Note No.	SVC-FSB-0021
Release Date	4/2/2014
Contact	ngceoservice@ngc.com

## eDrive Rotary Encoder

### Summary

**Original eDrive Rotary Encoder.**

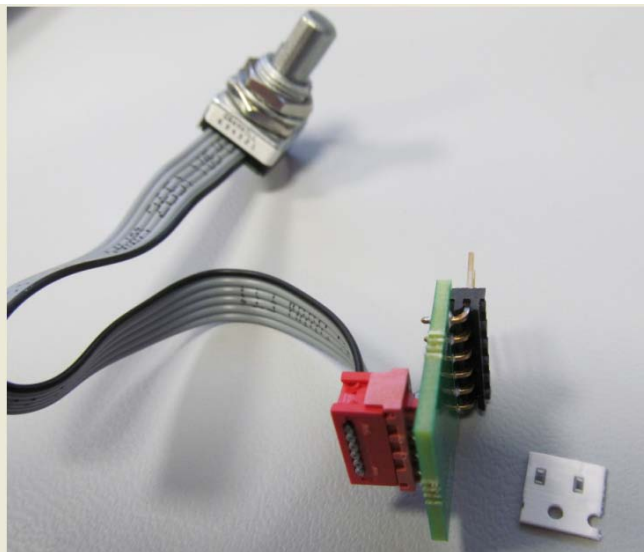
J13, R14, R15 (under J15) were not populated.

This rotary encoder became unavailable in 2011, and was replaced by the 81-173-20 kit.

**81-173-20, ASM, ROTARY ENCODER W.BOARD,ROHS**

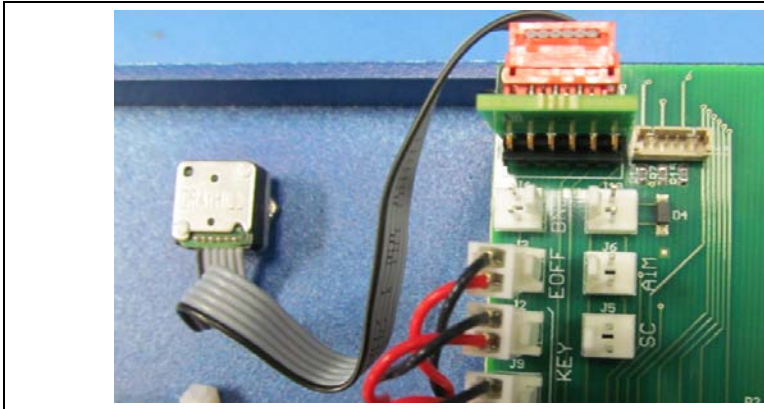
This kit can be used on any eDrive to replace the original rotary encoder that is no longer available.

The connector adaptor must be soldered on the eDrive front panel. Surface mount resistors R14 and R15 must be soldered on the front panel.
